MEMORANDUM

Subject: CUP-24-1-Conditional Use Permit Request for drive-in restaurant in the GC-General Commercial zoning district on 1.02 acres at 1421 South Main Street (Tax Map Nos. 287-22 1-5 & 287-22 102-105) by Balzer and Associates, LLC (applicant) for Blacksburg Square, LLC (owner).

CUP-24-1 Request for drive-in restaurant in GC at 1421 South Main Street

**Seven Brew Application Addenda May 28, 2024:**

**MASTER PLAN**

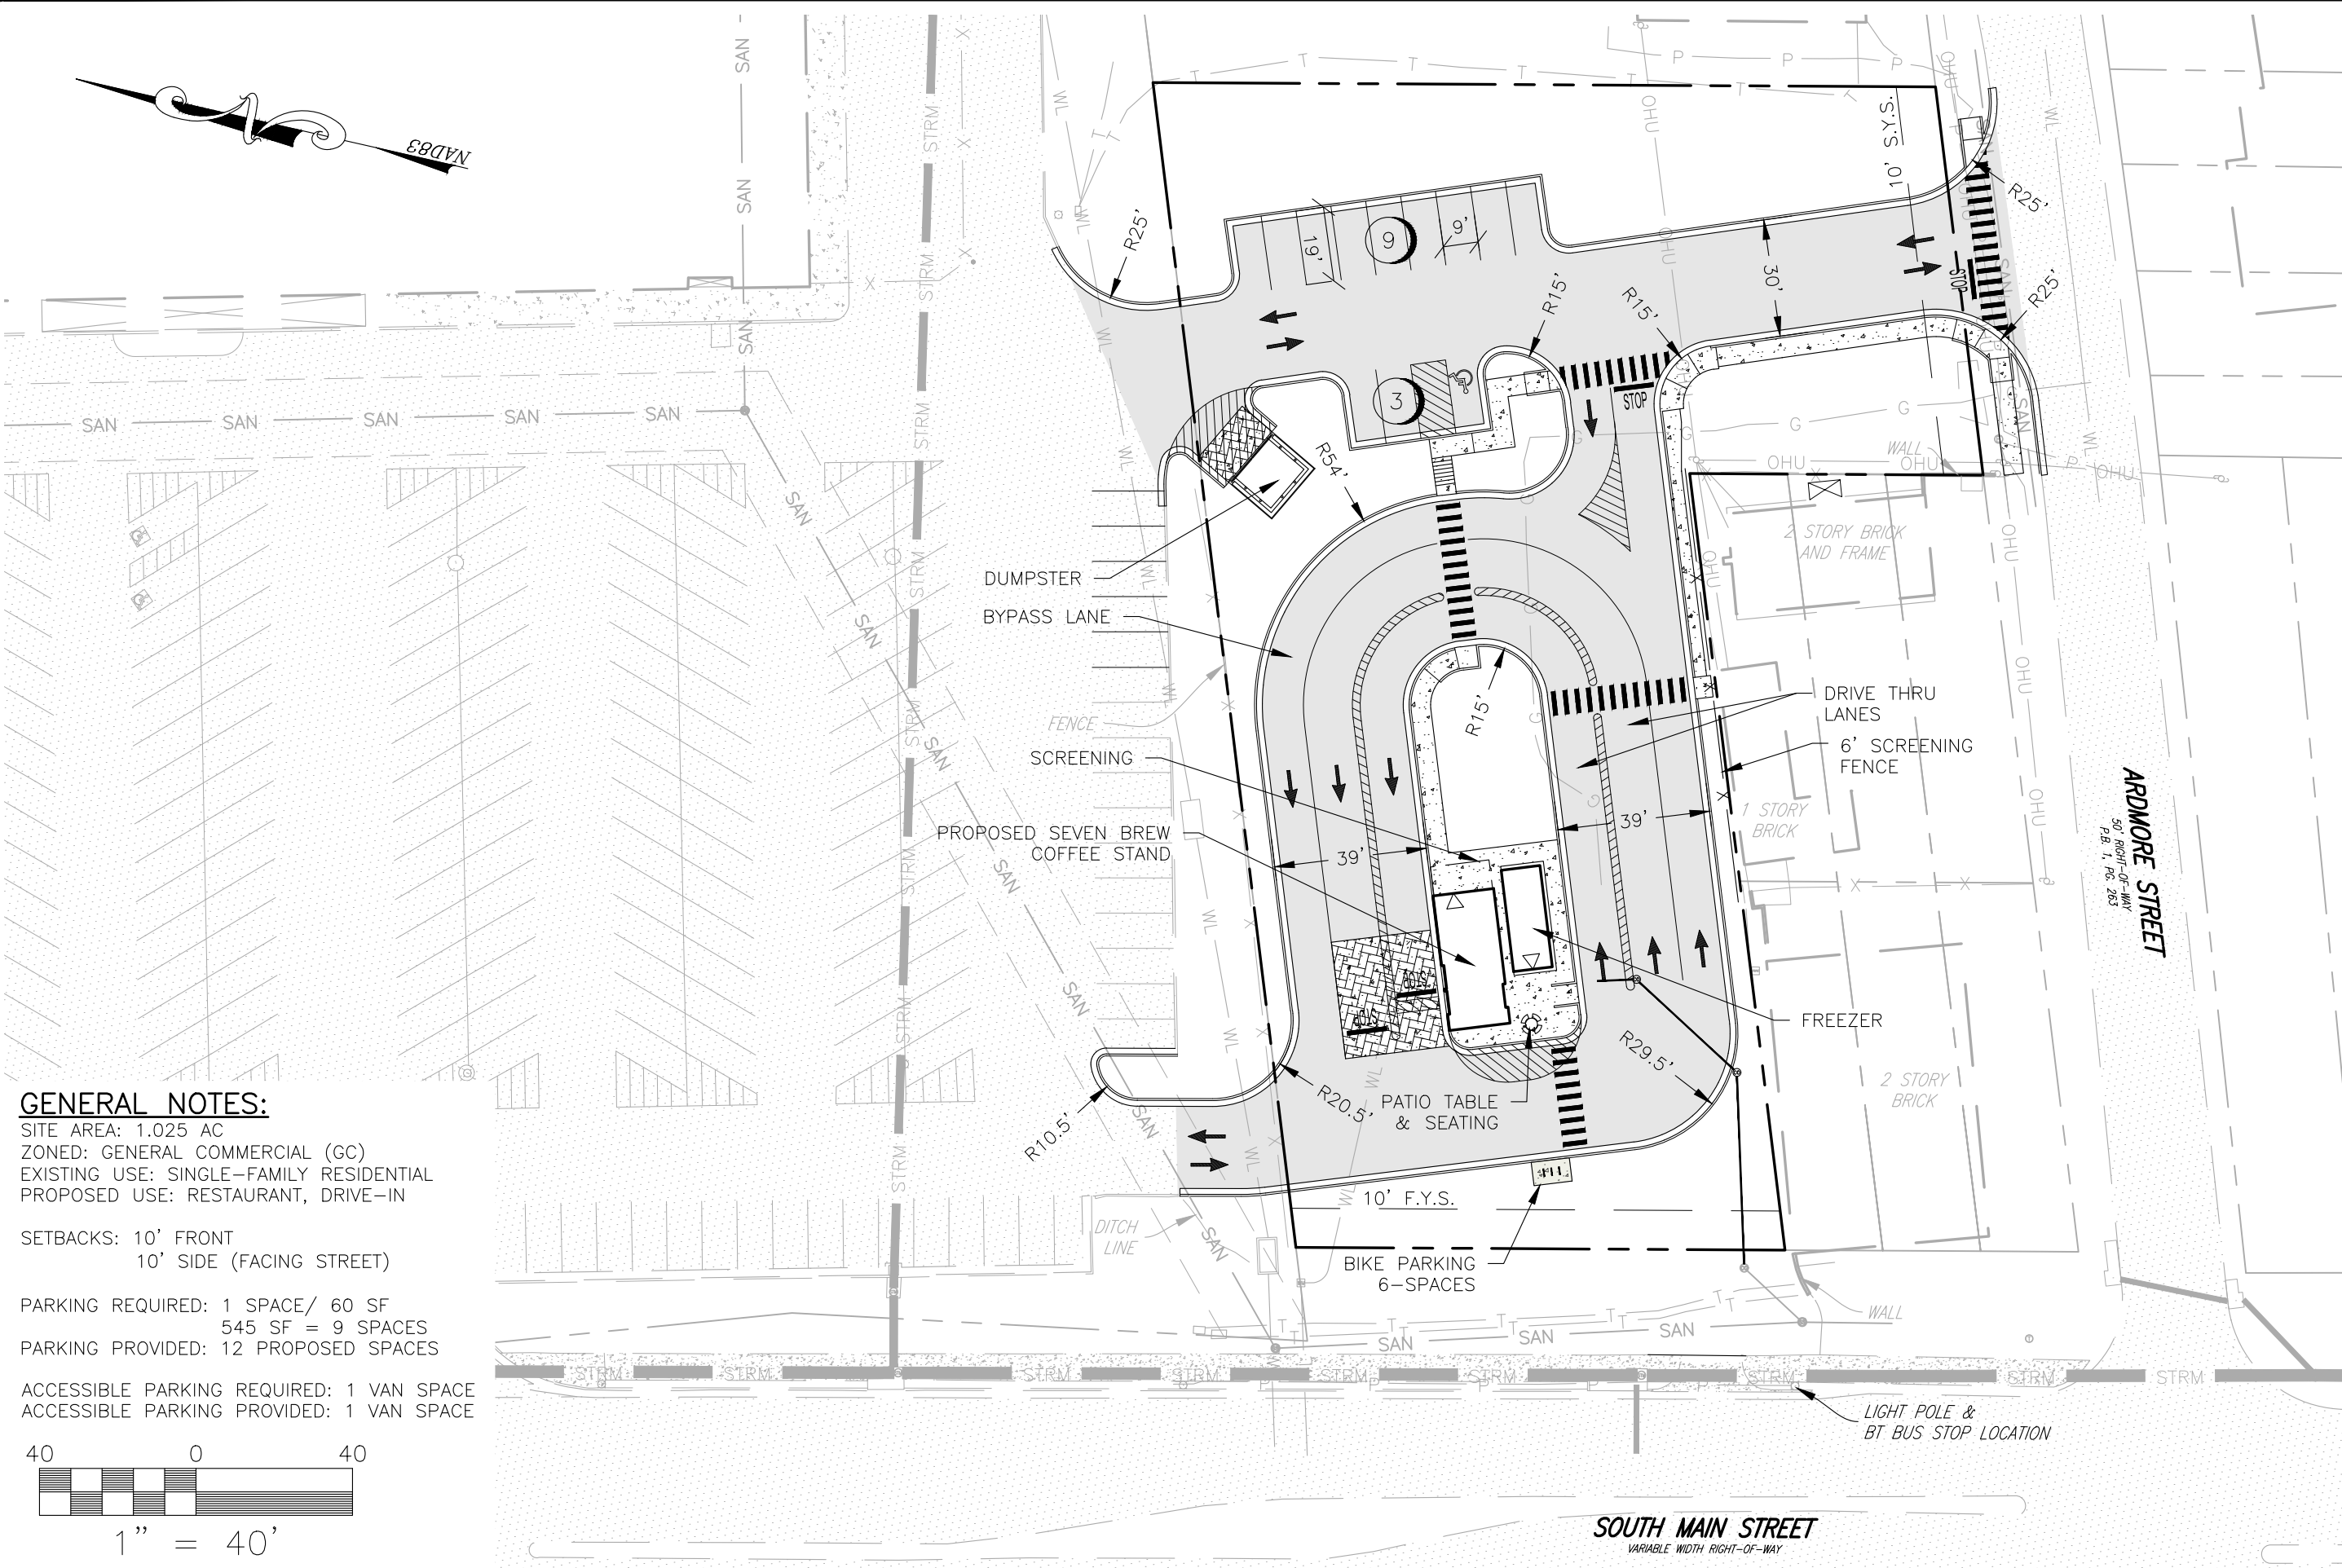
At the work session, there was discussion regarding the staff recommended condition to require an accessible route from the sidewalk/bus stop #1619 on South Main Street to the proposed coffee stand. The applicant is proposing to implement an accessible route from the proposed new sidewalk on their Ardmore Street frontage to the building, but stated that grading issues made providing an accessible route from the South Main frontage untenable. They expressed their willingness to work with the Town to provide a way to get to the business from the South Main sidewalk that is not accessible, if regulations allowed. In subsequent conversations with the applicant since the work session, they have expressed concerns that federal law would not allow a non-accessible route from a public sidewalk to the restaurant. Staff has consulted with the Town Building Official and Town Attorney on this topic, and is working with the applicant to resolve this issue. The Town Attorney has stated that Planning Commission can move forward with the condition as is, and any edits can be made prior to Council action.

No bike racks were shown on the initial application, and staff recommended a condition requiring the installation of five bicycle parking spaces. The racks are now shown on the revised application, therefore, the condition has been removed.

Staff explained that the original application showed 13 vehicular parking spaces including one ADA parking space being provided in the parking lot, but a maximum of 12 parking spaces were allowed. The applicant has revised the parking lot to show 12 spaces being provided.

**A2.1**  
EXTERIOR ELEVATIONS

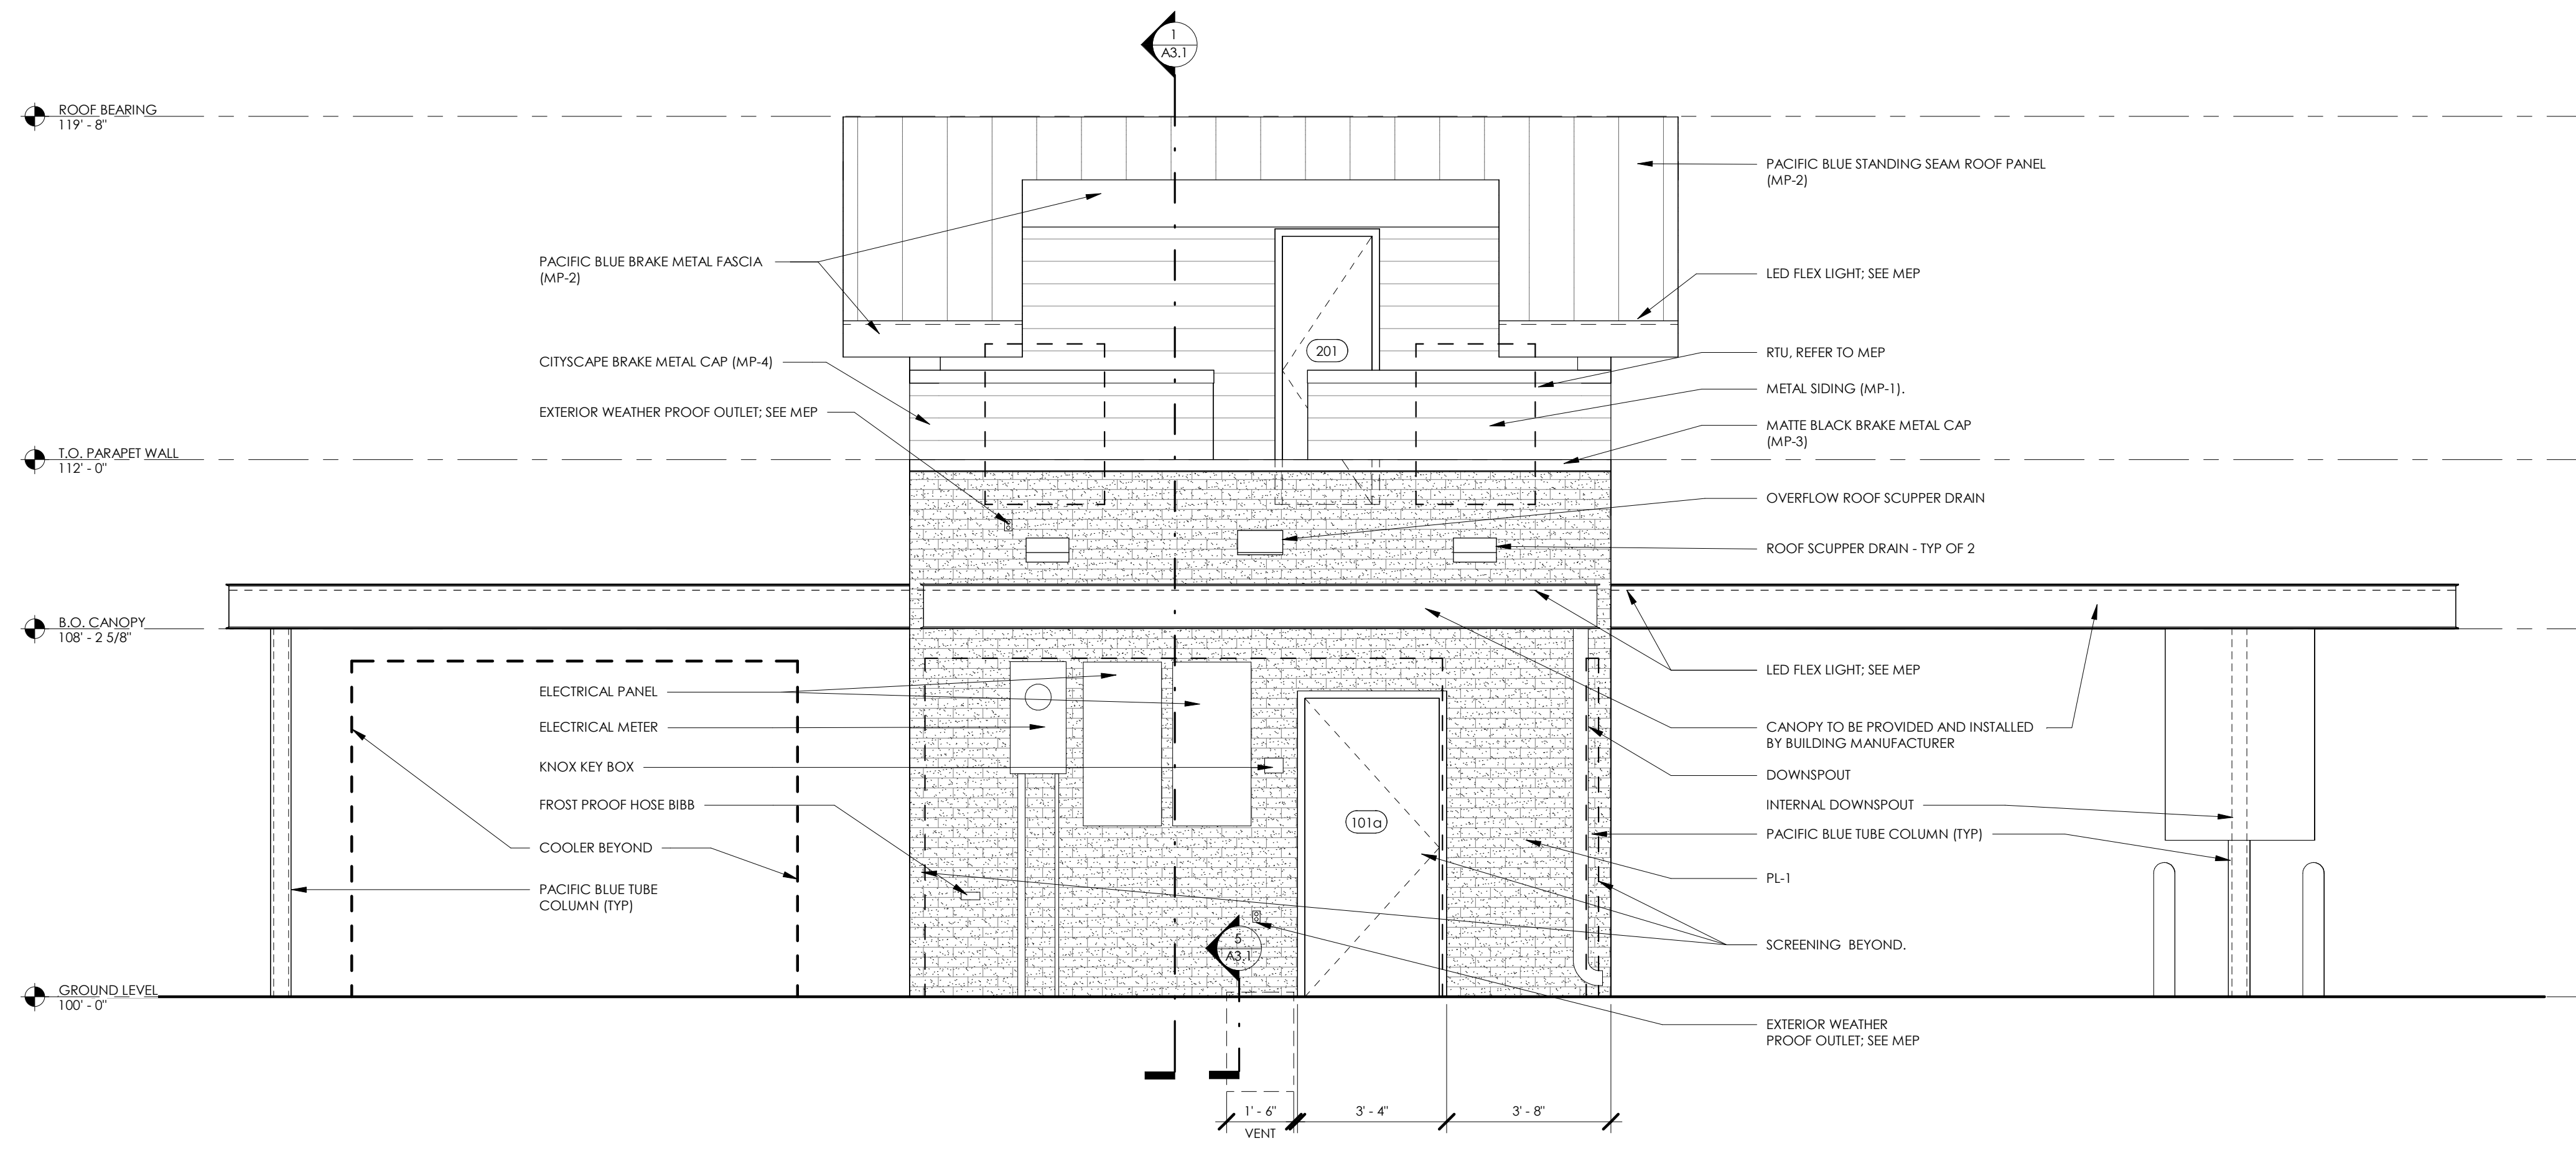
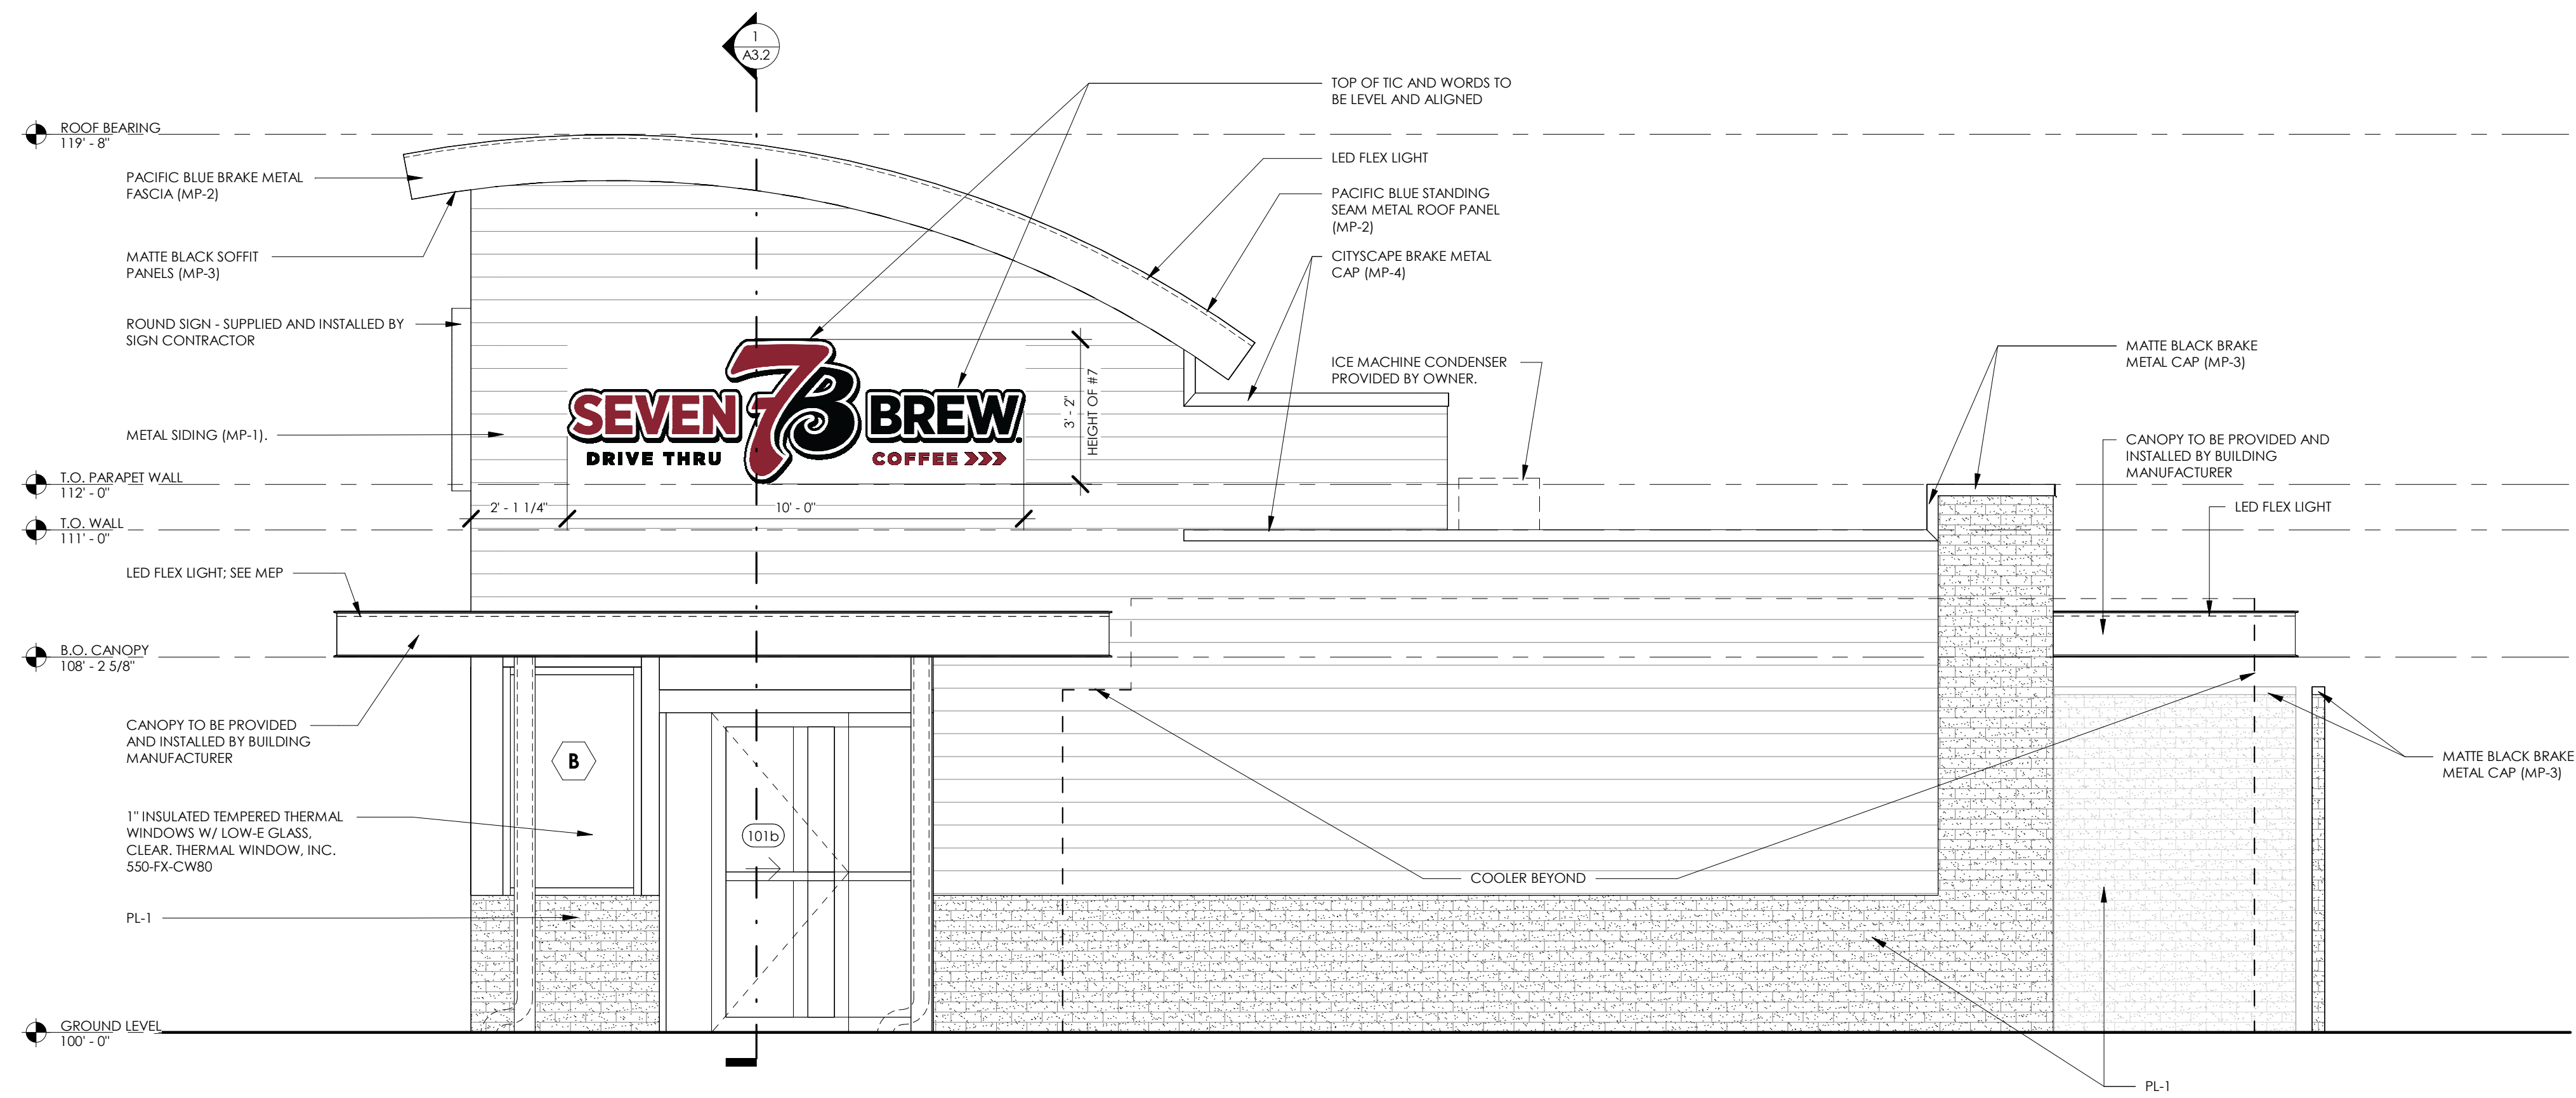
Staff showed the proposed signage that was provided with the application, and asked the applicant to provide dimensions of each façade to determine if the signage was in accordance with signage regulations in the zoning ordinance. The applicant provided those dimensions, and all business signage meets zoning ordinance standards. Though, the drawings show directional signs exceeding the size limit of 3 square feet. *The applicant should reduce the size of all directional signs to a maximum of 3 square feet.*
